## Staff Report

To: BOZAR  
From: Jessie Earley, Town Planner III  
Meeting Date: DRC, April 21, 2025  
RE: 2 Teocalli Avenue (Felton), Preliminary Review

**PROJECT TITLE:** Felton (2 Teocalli Avenue)

**SUMMARY:** Consideration of the application of **Edward L. Felton, Jr Trust Dated 12/28/1999** to site an addition to the primary building and to construct a cold accessory building to be located at 2 Teocalli Avenue, Lots 15 and 16, Block 7 in the R1 zone.

1 North - Streetscape Proposed  
1/8" = 1'-0"

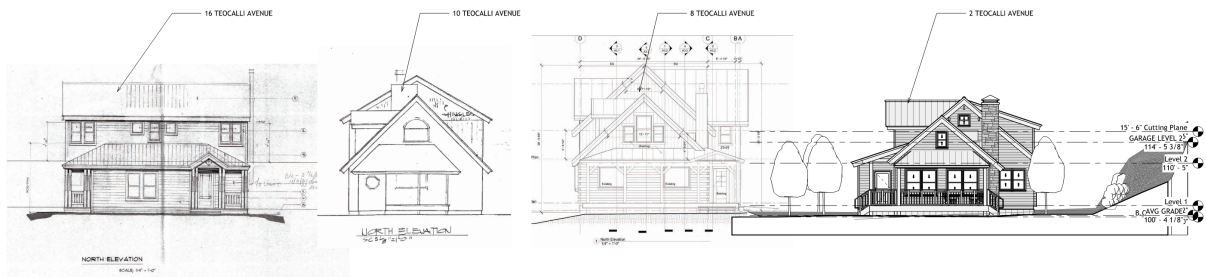
**II. Context:** Refer to guidelines 4.25-4.26. The neighborhood contains a mix of small 1 ½ story and two-story homes. The roof forms are relatively simple. Consider whether the forms and style of the additions will relate with the existing forms found within context and style of the neighborhood or if they will appear excessively dissimilar.

The Board should determine whether the overall scale and forms of the residence comply with the intents 4.25 and 4.26 (excessively similar or dissimilar) in relation to the neighborhood context.

GL	Staff Analysis	DRC Recommendation
4.25 Excessive similarity	The forms differentiate from the newer residences located in the 0 block of Teocalli Avenue per context GL 4.25.	
4.26 Excessive dissimilarity	<p>Discussion is encouraged to determine if the additions, as proposed, are contemporary interpretations and variety or if the proposal is excessively dissimilar.</p> <p>GL 4.46 c suggests that dormer types should not be mixed on a module when highly visible from the street. This appears to conflict with this GL, as it is apparent on the north elevation. Discussion is encouraged to determine if</p>

<p>this adds to the overall complexity of the building, as seen from the street.</p> <p>The chimney appears an odd feature, as proposed on the west. Consult GL 4.71.</p>	
--	---	--

**3** North - Proposed  
1/4" = 1'-0"

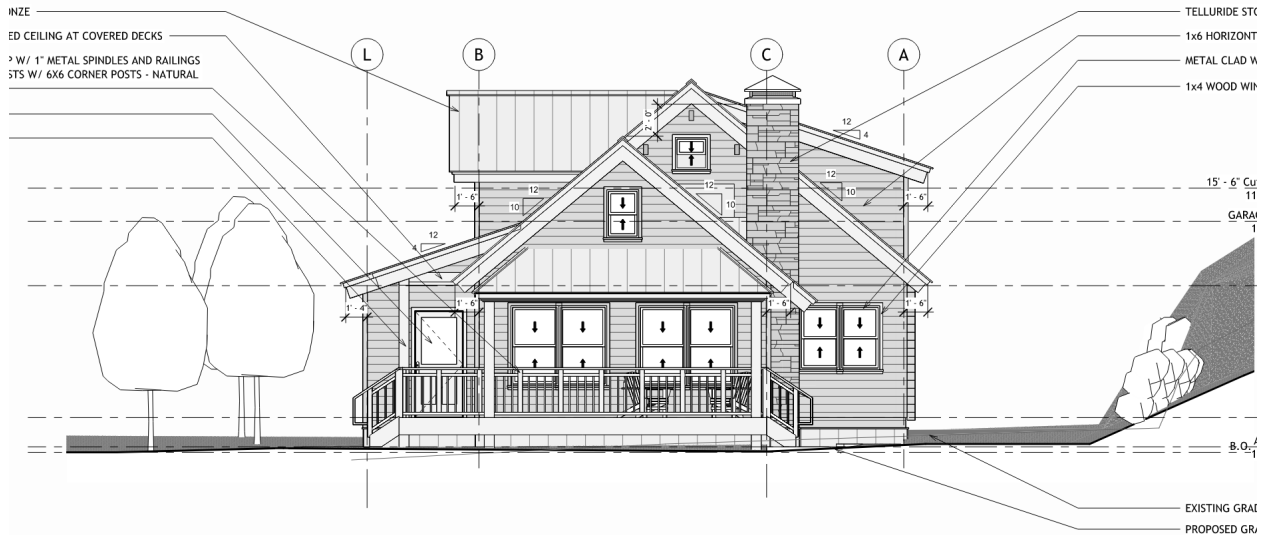
GL	Staff Analysis	DRC Recommendation
4.46 Dormers in new construction	<p><b>West shed:</b> There is a dormer proposed on the west elevation of the existing building module. It is a shed dormer. Shed dormers are not the dominant form in this neighborhood, as seen in the streetscape. Staff finds support.</p> <p><b>East gable:</b> There is a gable dormer proposed on the east elevation of the existing building module. Support</p> <p>GL 4.46 c suggests that dormer types should not be mixed on a module when highly visible from the street. This appears to conflict with this GL, as it is apparent on the north elevation.</p>

**West shed:** The dormer steps down 8" from the ridge of the module, but appears large on this elevation.

a. **West shed:** The dormer, as proposed occupies 32.1% of the roof, which is in conflict with this GL that requires 30%.

b. **West shed:** The dormer is lower than the ridge. There is a section of roof beneath, support.

**East gable:** The dormer is lower than the ridge. There is a section of roof beneath, support.

d. **West shed:** The dormer as proposed is in the middle 70% of the roof form.

e. **West shed:** The vertical wall of the dormer is 4'11". This must be reduced to 4' to meet the intents of the GL.

#### 4/21 DRC: Elevations glazing

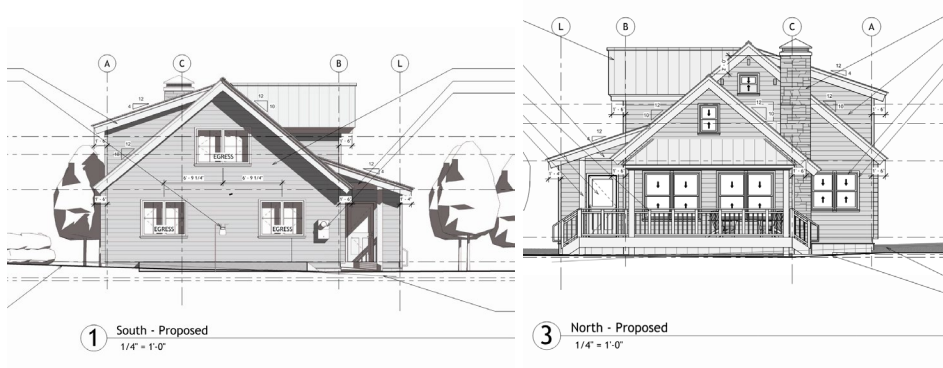
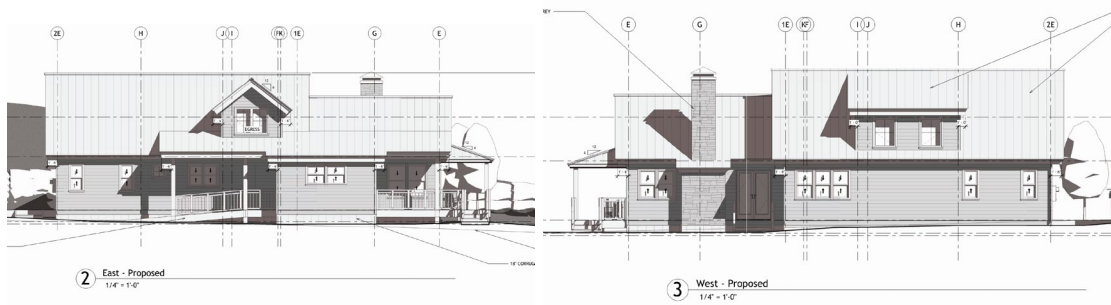
GL	Staff Analysis	DRC Recommendation
<p>4.53/5.43 Window to wall ratio</p>	<p>Window to wall ratios along the front elevation (north) proposes 108.6 sf of glazing/576.16 sf wall space, which is 18.8% window to wall.</p> <p>The building exists with two large picture windows and door glazing on the front elevation and two triangular windows and a rectangle within the gable.</p> <p>The first floor proposes three, two packs and door glazing (85.9 sf). There is a single window in each of the gables (4.01 and 5.01 sf), which meets the intents of the GL.</p> <p>On the west elevation there are currently no windows. This proposal is for two single windows, a three pack, a two pack and door glazing on the first floor. Then, there are two single windows on the second floor.</p> <p>On the east elevation, there are two, two packs that are existing. The proposed elevation is for three, two packs of windows and three single windows on the first floor, and a two pack on the second floor.</p> <p>The south elevation proposes two, two packs on the first floor, and a two pack within the second floor gable.</p>

<p>4.54 Vertical emphasis</p>	<p>Some windows are proposed as two over two, and others are proposed as a one over one. One style should be chosen. Windows are double hung and double hung style casement windows, which is consistent with historic homes. A window schedule has not been included but should be.</p> <p>The windows are proposed as casement and double hung, which is supported by GL 4.54 a. Window operations have been noted on the plans. These windows must have simulated divided lights, which are noted on the plans and materials list.</p> <p>A limited number of small square windows are allowed per GL 4.54 c and there is one window on the east</p>

4.58 Groupings of 2 or more windows	All three packs of windows must have 3.5" of dividing trim because this is a core zone. These windows cannot be mulled. This must be revised for the three pack on the west elevation.  The two packs on all elevations appear to meet the intents of this GL.

4.58 c. Window sizes	The front elevation does not propose more than four window sizes, support.  It appears that there are no more than six sizes on the north, east, and west.

4.59 Window and door trim	Wood trim is noted (1"x4" wood). Trim surrounds appear consistent with the GL.	
4.60 Divided lights	Confirmation that simulated divided light windows will be provided is needed.  Some windows are proposed as two over two, and others are proposed as a one over one. One style should be chosen
